SOLICITATION AMENDMENT MODIFICATION DE L'INVITATION

Title - Sujet Seawater System and Pumphouse Const	
Solicitation No. - N° de l'invitation EB144-190610/A	Amendment No. - N° modif. 004
Client Reference No. - N° de référence du client EB144-19-0610	Date 2018-08-03
GETS Reference No. - N° de référence de SEAG PW-\$PWA-104-5757	
File No. - N° de dossier PWA-8-80026 (104)	CCC No./N° CCC - FMS No./N° VME
Solicitation Closes - L'invitation prend fin at - à 02:00 PM on - le 2018-08-09	Time Zone Fuseau horaire Atlantic Daylight Saving Time ADT
F.O.B. - F.A.B. Plant-Usine: <input type="checkbox"/> Destination: <input checked="" type="checkbox"/> Other-Autre: <input type="checkbox"/>	
Address Enquiries to: - Adresser toutes questions à: Nowakowski, Leanne	Buyer Id - Id de l'acheteur pwa104
Telephone No. - N° de téléphone (902) 403-7112 ()	FAX No. - N° de FAX (902) 496-5016
Destination - of Goods, Services, and Construction: Destination - des biens, services et construction:

Amendment 004 is being issued to provide further questions and answers, as well as additional sketches, drawings and information that should form part of the submission.

CANADIAN COAST
GUARD COLLEGE,
SYDNEY, NS
SEAWAT

12-E-SK001

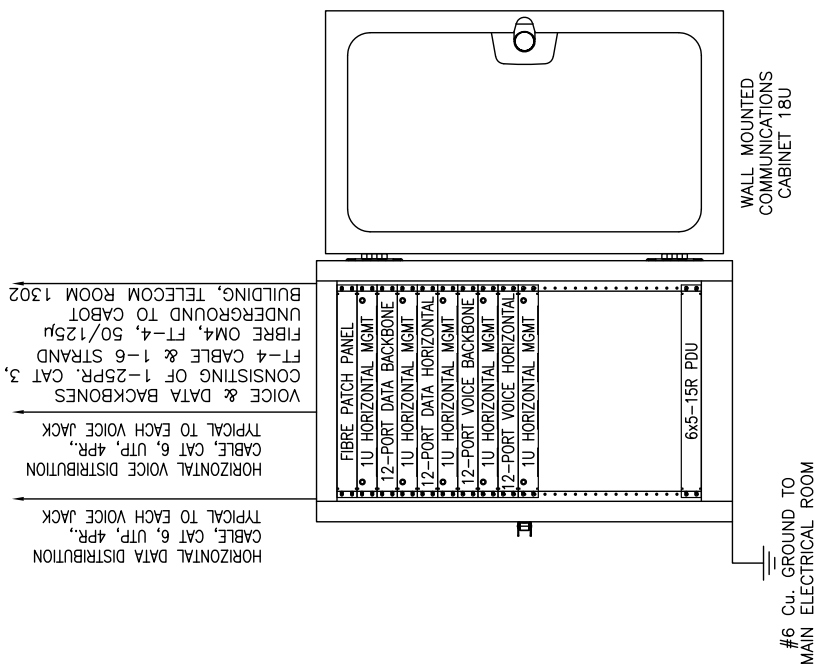
- .1 Revise the fire alarm annunciator shown to be a fire alarm panel (to match existing system throughout campus, Simplex 4100U) to support new devices and tie-in to existing campus system. Refer to riser on sketch 12-E-SK001.
- .2 Supply and install a wall mounted communications rack in Seawater Pumphouse c/w accessories as indicated on sketch 12-E-SK002.

1. INITIATION LOOP WIRING IS TO BE 2C#18 AWG CU. MINIMUM, AND IN ACCORDANCE WITH MANUFACTURERS REQUIREMENTS.
2. ANNUNCIATION LOOP WIRING IS TO BE 2C#14 AWG CU. + #12 CU. BOND, MINIMUM, AND IN ACCORDANCE WITH MANUFACTURERS REQUIREMENTS.
3. REMOTE FIRE ALARM PANEL WIRING IS TO BE 1PR. #14 CU. TWISTED SHIELDED + 1PR. #18 CU. TWISTED SHIELDED CABLE.
